Access Audit Site Report

Lost Maples State Natural Area

Accessibility Evaluation

Inspection Date: 03/24/2022

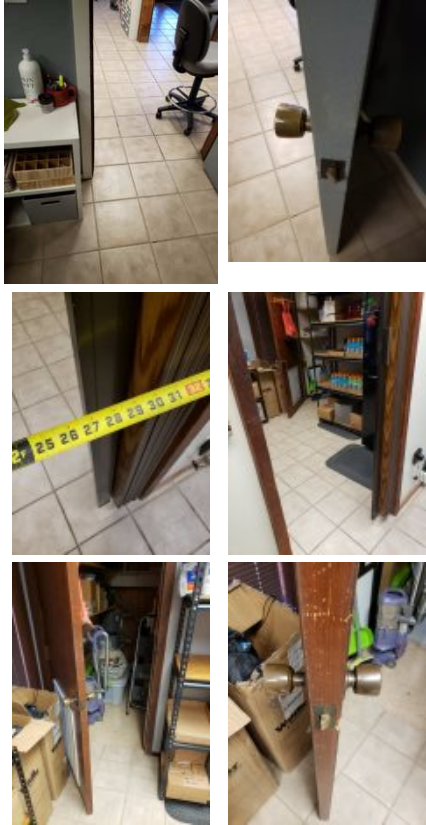
Finding Number	Area Description	Lat/Long	Finding	As Built	Recommendation	Citation	Photos	Figure
15	Headquarters Area: HQ - Public Spaces	[29.80777, -99.57067]	There is no drinking fountain for standing persons. Spout outlets of drinking fountains for standing persons shall be 38 inches minimum and 43 inches maximum above the finish floor or ground.	Low bowl only	Add second high bowl fountain for standing persons.	2015 ABAAS Section: 602.7 2012 TAS Section: 602.7 2010 ADAS Section: 602.7, 211.2		
16	Headquarters Area: HQ - Public Spaces	[29.80777, -99.57067]	An item or items project more than 4 inches into the circulation path. Wall-mounted objects that have leading edges between 27 inches and 80 inches from the floor must not project more than 4 inches into the circulation path. Protruding objects that extend to the floor or within 27 inches of the floor are cane detectable and are therefore not hazardous. Where it is necessary or desirable to have objects protrude from the wall, a manner of cane detection must be provided.	Drinking fountain projects 18" into walkway	Relocate protruding objects or place cane detectable warning or bollard at foot of item.	2015 ABAAS Section: 307.2 2012 TAS Section: 307.2 2010 ADAS Section: 307.2

17	Headquarters Area: HQ - Employee Spaces	[29.80777, -99.57067]	The accessible route contains running slopes greater than 5 percent and cross slopes greater than 2 percent across the width of the walk and has not been constructed as a ramp (i.e. handrails, wheel guides, etc.). When the slope in the direction of travel of any walk exceeds 1 unit vertical in 20 units horizontal (5-percent slope), it must be constructed as ramp. Surface cross slopes must not exceed one unit vertical in 48 units. Horizontal (2-percent slope).	Break Room - 12.4% at drain	Correct or repair slope to max 5% running and 2.08% cross.	2015 ABAAS Section: 403.3 2012 TAS Section: 403.3 2010 ADAS Section: 403.3

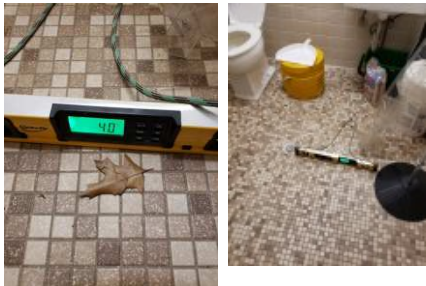
Finding Number	Area Description	Lat/Long	Finding	As Built	Recommendation	Citation	Photos	Figure
23	Headquarters Area: HQ - Storage Room Restroom	[29.8077374 , -99.570723 6]	The threshold at a doorway shall be no higher than 1/2 inch. Changes in level between 1/4 inch and 1/2 inch must be beveled at 1:2 or less. 1/4 inch is the maximum vertical rise. All interior doors must be maintained so that the operating pressure does not exceed 5 lb. force to open. The sweep period for doors with closers shall be adjusted so that from an open position of 70 degrees, the door will take at least 3 seconds to move to a point 3 inches from the latch, measured to the leading edge of the door.	Door - 1" CIL at threshold, 20 lbf, fast close	For all doors along the public circulation route, repair, provide beveled threshold. For all doors along the public circulation route, inspect, adjust, and maintain 5 lbf to open interior doors. For all doors along the public circulation route, inspect, adjust, and maintain closing speed on door closers.	2010 ADAS Section: 404.2.3, 404.2.7, 404.2.4, 404.2.11, 404.2.11 Exception

24	Headquarters Area: HQ - Storage Room Restroom	[29.8077339 , -99.570722 3]	The restroom sign does not comply with one or more applicable requirements for the location, height, and properties of the sign.	Restroom is currently used as a storage room	Acquire and mount signage, including Braille, raised lettering and access symbol mounted on wall, latch side of door, 48" to baseline of lowest character and 60" to baseline of highest character if reinstated as a restroom.	2015 ABAAS Section: F216.2, 703.1, 703.2, 703.5, 703.6 2012 TAS Section: 216.2, 703.1, 703.2, 703.5, 703.6 2010 ADAS Section: 216.2, 703.1, 703.2, 703.5, 703.6		
25	Headquarters Area: HQ - Storage Room Restroom	[29.8077328 , -99.570721]	The mirror is mounted too high. Mirrors must have the bottom edge of the reflecting surface a maximum of 40 inches above the floor if above a sink or counter. Mirrors not located above lavatories or countertops shall be installed with the bottom edge of the reflecting surface 35 inches maximum above the finish floor or ground.	41.5" AFF	Lower mirror so reflective surface is max 40" AFF.	2015 ABAAS Section: 603.3 2012 TAS Section: 603.3 2010 ADAS Section: 603.3

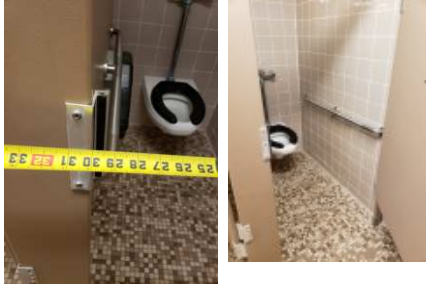
Finding Number	Area Description	Lat/Long	Finding	As Built	Recommendation	Citation	Photos	Figure
51	Camping: Camping - Parking	[29.8096866 , -99.573043 8]	The cross slopes (narrow dimension) and/or running slopes (long dimension) of the accessible stall exceeds 2%. The running slope and the cross slope in an accessible parking stall and the access aisle must not exceed 2%.	2.5% in stall	Correct or repair slope of stall to max 2.08% in any direction.	2015 ABAAS Section: 502.4 2012 TAS Section: 502.4 2010 ADAS Section: 502.4		
52	Camping: Camping - Parking	[29.8096842 , -99.573043 8]	The parking stall contains abrupt edges and surface irregularities over a 1/4 inch vertical. Parking spaces and access aisles serving them shall be stable, firm, and slip resistant. Access aisles shall be at the same level as the parking spaces they serve. Changes in level are not permitted and shall not be sloped steeper than 2% in any direction.	Deteriorated asphalt, gravel, and grass	Resurface accessible stalls and access aisles with a firm, stable, and slip resistant material. Cost included in previous finding	2015 ABAAS Section: 502.4 2012 TAS Section: 502.4 2010 ADAS Section: 502.4

53	Camping: Campsite	[29.809882, -99.572960 6]	Camping facilities shall provide camping units with mobility features complying with F244.2 in accordance with Table F244.2. Where a camping facility provides different types of camping units, Table F244.2 shall apply to each type of camping unit provided. Total Number of Camping Units Provided in Camping Facility Minimum Number of Camping Units with Mobility Features Required 1 1 2 to 25 2 26 to 50 3 51 to 75 4 76 to 100 5 101 to 150 7 151 to 200 8 201 and over 8, plus 2 percent of the number over 200	Campsite 23 is representative of sites in this area - no accessible features at this or any other sites; 0 of 30 sites accessible	Create the required number of accessible camp sites per table F244.2 as a smart practice	2015 ABAAS Section: F244.2

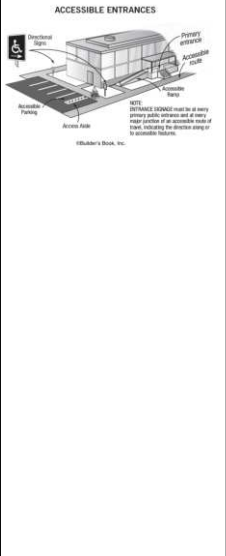
Finding Number	Area Description	Lat/Long	Finding	As Built	Recommendation	Citation	Photos	Figure
72	Camping: Camping - Womens Restroom	[29.8095807 , -99.573003 5]	The stall door fails to comply with all of the door requirements. The stall door must be a minimum of 32" wide and stall door must be self-closing.	stall door 30" wide, not self closing	Widen stall doors to 32" when opened to 90 degrees. Adjust stall door to be self-closing.	2015 ABAAS Section: 404.2.3, 404.2.7, 604.8.2.2 2012 TAS Section: 404.2.3, 404.2.7, 604.8.2.2 2010 ADAS Section: 404.2.3, 404.2.7, 604.8.2.2		
73	Camping: Camping - Womens Restroom	[29.8095865 , -99.572988 8]	The grab bar height and/or spacing fails. Grab bars must be mounted between 33" and 36" to the top of the gripping surface. There must be 1.5" of clearance between the grab bar and the wall. There must be a minimum of 1.5" of clearance below and minimum 12" above the grab bar to any dispenser or other obstruction.	Dispenser touching bottom of bar	Remount toilet paper dispenser max 7" to 9" from front of toilet, 15" to 48" above the finished floor (AFF) and min 12" above or 1.5" below grab bar.	2015 ABAAS Section: 609.3, 609.4 2012 TAS Section: 609.4, 609.3 2010 ADAS Section: 609.3, 609.4

74	Camping: Camping - Womens Restroom	[29.809576, -99.572998 2]	An item or items project more than 4 inches into the circulation path. Wall-mounted objects that have leading edges between 27 inches and 80 inches from the floor must not project more than 4 inches into the circulation path. Protruding objects that extend to the floor or within 27 inches of the floor are cane detectable and are therefore not hazardous. Where it is necessary or desirable to have objects protrude from the wall, a manner of cane detection must be provided.	Hand dryer projects 7"	Relocate protruding objects or place cane detectable warning or bollard at foot of item.	2015 ABAAS Section: 307.2 2012 TAS Section: 307.2 2010 ADAS Section: 307.2

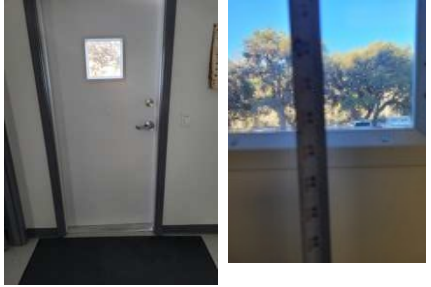
Finding Number	Area Description	Lat/Long	Finding	As Built	Recommendation	Citation	Photos	Figure
84	Camping: Camping - Restroom Amenities	[29.8096365, -99.5730518]	The walkway contains abrupt vertical edges and/or variations over a 1/4 inch. 1/4 inch is the maximum vertical rise. Changes in level between 1/4 inch and 1/2 inch must be beveled at 1:2 or less. Changes in level greater than 1/2 inch must be by way of a ramp.	1" CIL at women's restroom	Repair, bevel or ramp change in level along accessible route.	2012 TAS Section: 303.2, 303.3 2010 ADAS Section: 303.2, 303.3		
85	Camping: Camping - Restroom Amenities	[29.80959, -99.5729526]	The walkway contains abrupt vertical edges and/or variations over a 1/4 inch. 1/4 inch is the maximum vertical rise. Changes in level between 1/4 inch and 1/2 inch must be beveled at 1:2 or less. Changes in level greater than 1/2 inch must be by way of a ramp.	1.5" CIL at men's restroom	Repair, bevel or ramp change in level along accessible route.	2012 TAS Section: 303.2, 303.3 2010 ADAS Section: 303.2, 303.3

86	Camping: Camping - Dump Station	[29.8092863, -99.5733428]	72 inches (1830 mm) by 48 inches (1220 mm) with the long side of the space adjoining or overlapping an outdoor recreation access route or trail, as applicable, or another clear ground space. Locate the space so that the water spout is 11 inches (280 mm) minimum and 12 inches (305 mm) maximum from the rear center of the long side of the space	Deteriorated asphalt	Provide required clear ground space at water hydrant as a smart practice	2015 ABAAS Section: 1011.2

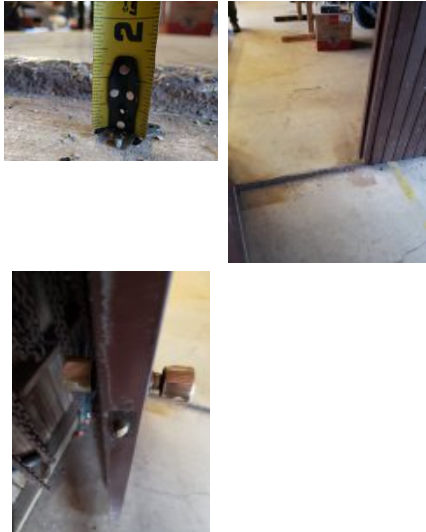
Finding Number	Area Description	Lat/Long	Finding	As Built	Recommendation	Citation	Photos	Figure
87	Employee Areas: Maintenance - Parking and Exterior Accessible Route	[29.80777, -99.57067]	Element meets all standards and requirements	Parking lot complies with scoping - 6 standard, 1 accessible	None	2010 ADAS Section: N/A		
88	Employee Areas: Maintenance - Parking and Exterior Accessible Route	[29.8127772, -99.5754738]	The access aisle is not a minimum 5 feet wide. A car accessible parking stall's access aisle must be a minimum of 5 feet wide measured from centerline to centerline. Where the access aisle is not adjacent to another parking space or access aisle, measurements shall be permitted to include the full width of the line defining the access aisle.	Access aisle is 58" width edge to edge instead of center of stripe, total width of parking stall and aisle is 16'	Repaint access aisles to be 5' each.	2015 ABAAS Section: 502.3.1 2012 TAS Section: 502.3.1 2010 ADAS Section: 502.3.1

89	Employee Areas: Maintenance - Parking and Exterior Accessible Route	[29.8127853, -99.5754564]	The ramps slope exceeds the maximum running slope (direction of travel) allowable of 8.33%. Ramps should have the least possible slope but in no case more than 8.3% (1:12).	8.8% slope on ramp	Correct slope of ramp to max 8.33%.	2015 ABAAS Section: 405.2 2012 TAS Section: 405.2 2010 ADAS Section: 405.2

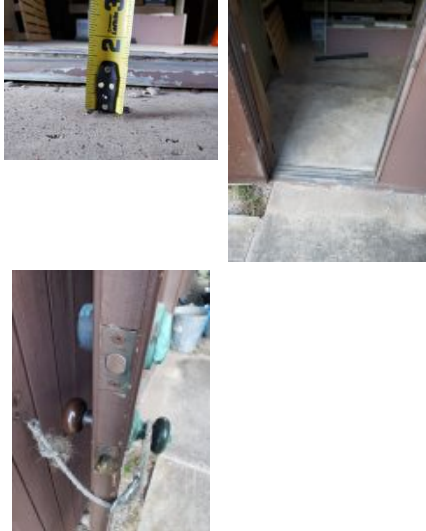
Finding Number	Area Description	Lat/Long	Finding	As Built	Recommendation	Citation	Photos	Figure
94	Employee Areas: Maintenance	[29.8125153 , -99.575444 8]	Minimum maneuvering clearances at doors and gates shall comply with 404.2.4. Maneuvering clearances shall extend the full width of the doorway and the required latch side or hinge side clearance.	Table on push side of 2nd office	Provide required maneuvering clearance on push side of door Relocate obstacles to provide 48" maneuvering clearance around door.	2015 ABAAS Section: 404.2.4.4, 404.2.4.1 2012 TAS Section: 404.2.4.4, 404.2.4.1 2010 ADAS Section: 404.2.4.4, 404.2.4.1		
95	Employee Areas: Maintenance	[29.8125356 , -99.575481 3]	Exterior doors are recommended to be maintained at 8.5 lbf as a smart practice. Force is to be measured at the operating hardware or 30 inches from the hinges, whichever is greater. Doors, gates, and side lights adjacent to doors or gates, containing one or more glazing panels that permit viewing through the panels shall have the bottom of at least one glazed panel located 43 inches (1090 mm) maximum above the finish floor.	2 of 2 doors at office stick, requires a firm push open, window 57.5"	For all doors along the public circulation route, replace doors with ones having sidelight viewing windows max 43" AFF.	2010 ADAS Section: 404.2.3, 404.2.7, 404.2.4, 404.2.11, 404.2.11 Exception

96	Employee Areas: Maintenance	[29.8125607 , -99.575485 9]	The stripe on the stair tread does not contrast adequately with the stair tread. Exterior and interior stairs are recommended to have the upper approach and lower treads marked by a stripe providing clear visual contrast.	Exterior Stairs at office - treads lack visual contrast	SMART PRACTICE Install contrasting strip along front 2" of each tread The stripe shall be a minimum of 2 inches wide to a maximum of 4 inches wide placed parallel to, and not more than 1 inch from, the nose of the step or upper approach. The stripe shall extend the full width of the step or upper approach and shall be of material that is at least as slip resistant as the other treads of the stair. A painted stripe shall be acceptable. Grooves shall not be used to satisfy this requirement.	2015 ABAAS Section: Advisory 504.4 2012 TAS Section: 504.4 Advisory 2010 ADAS Section: 504.4

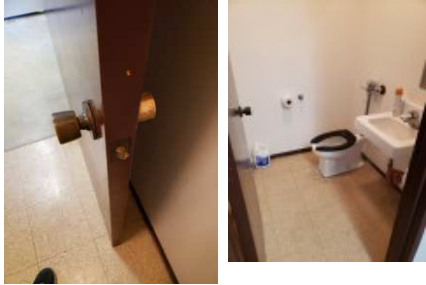
Finding Number	Area Description	Lat/Long	Finding	As Built	Recommendation	Citation	Photos	Figure
99	Employee Areas: Maintenance	[29.8125107 , -99.5754497]	Spaces and elements within employee work areas shall only be required to comply with 206.2.8, 207.1, and 215.3 and shall be designed and constructed so that individuals with disabilities can approach, enter, and exit the employee work area. Employee work areas, or portions of employee work areas, other than raised courtroom stations, that are less than 300 square feet (28 m2) and elevated 7 inches (180 mm) or more above the finish floor or ground where the elevation is essential to the function of the space shall not be required to comply with these requirements or to be on an accessible route.	Shop Building - 1" CIL at door, knobs	Repair, bevel, or ramp CILs at door entries to max .25". Replace hardware with lever hardware or hardware operable without a tight pinch or grasp.	2015 ABAAS Section: F203.9 2012 TAS Section: 203.9 2010 ADAS Section: 203.9
